# ORIGINATION FORM

Proposed Revisions to a Standard Plans Index  
(Please provide all information – Incomplete forms will be returned)

Index Number: **700-020**  
Sheet Number (s): 1-3  
Index Title: Multi-Column Ground sign

MULTI-COLUMN SIGN ASSEMBLY

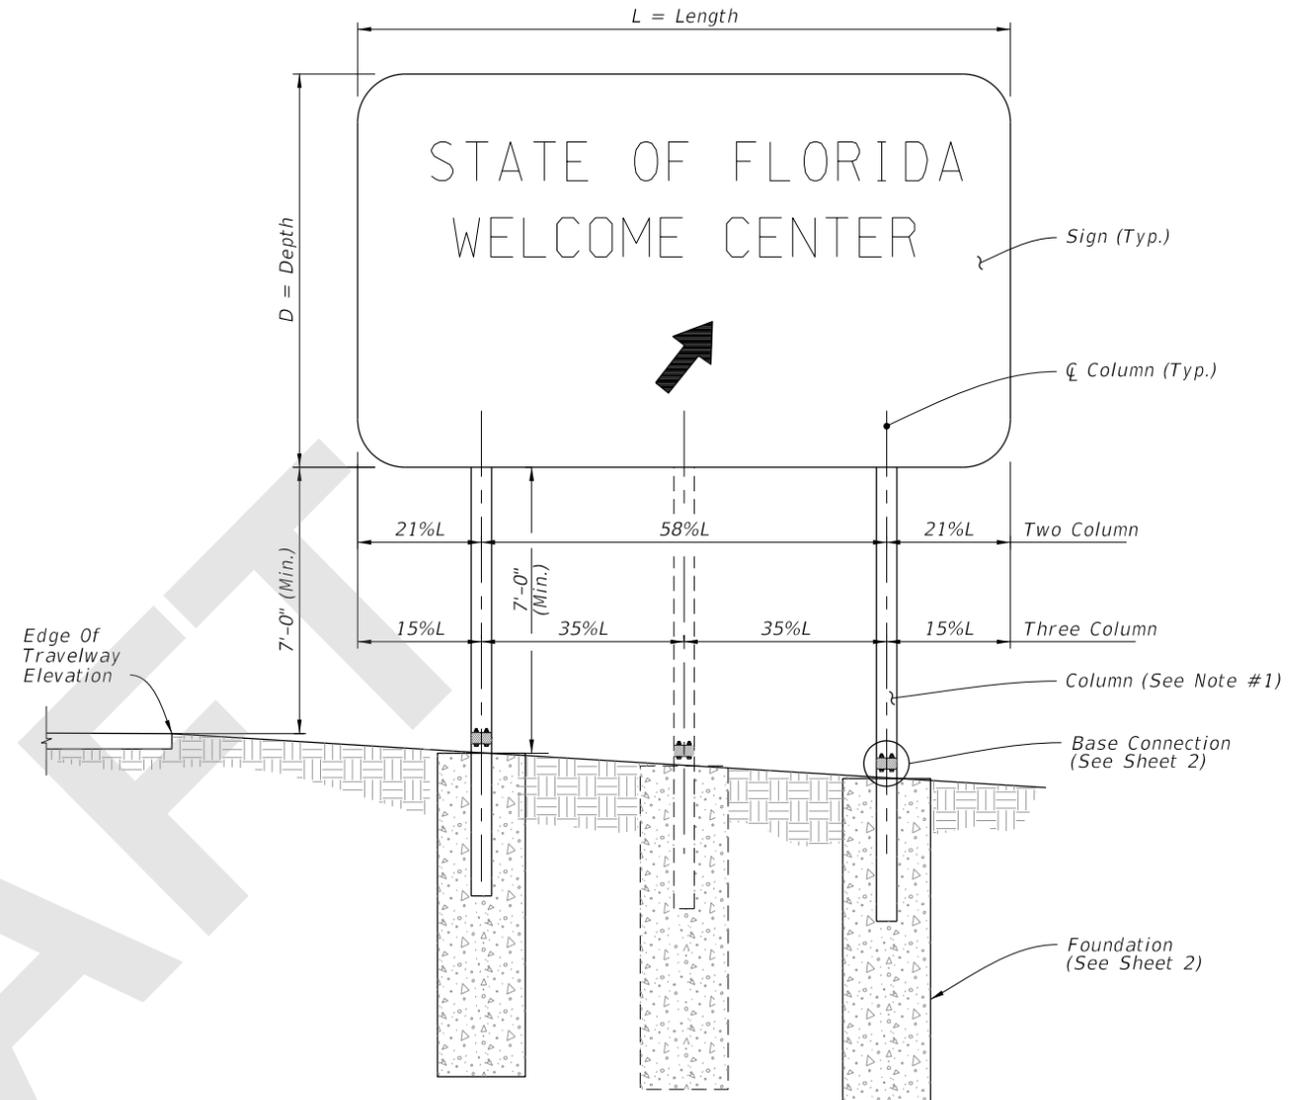
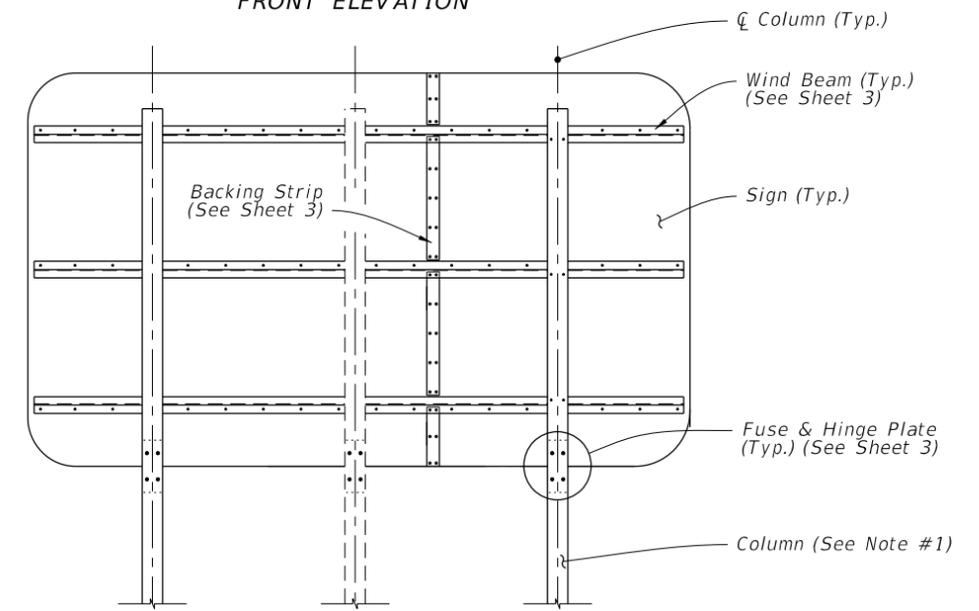
Sheet 1: Changed three column spacing; Clarified Note 2 A & B; Changed Note 3 B-c to allow brass or galvanized shims; Sheet 2: Corrected weld symbols; Changed Section A-A; Changed Note 1B; Sheet 3: Clarified that bolt through sign can be button or flat head; added note to use nylon washer under button head (from Index 700-020); Changed Wind Beam Tables.

Changed to allow both brass and galvanized shims. Weld symbols are redundant./incorrect. Tried to clarify column sections are steel. Wind Beam Tables were reorganized to clarify size based on length and # based on Depth.

- b. Steel Weld Metal: E70XX
    - c. Shims: Brass ASTM B36 or Galvanized Steel
  - C. Aluminum Bolts, Nuts and Washers:
    - a. Flat Head and Button Head Bolts: ASTM F 468, Alloy 2024-T4
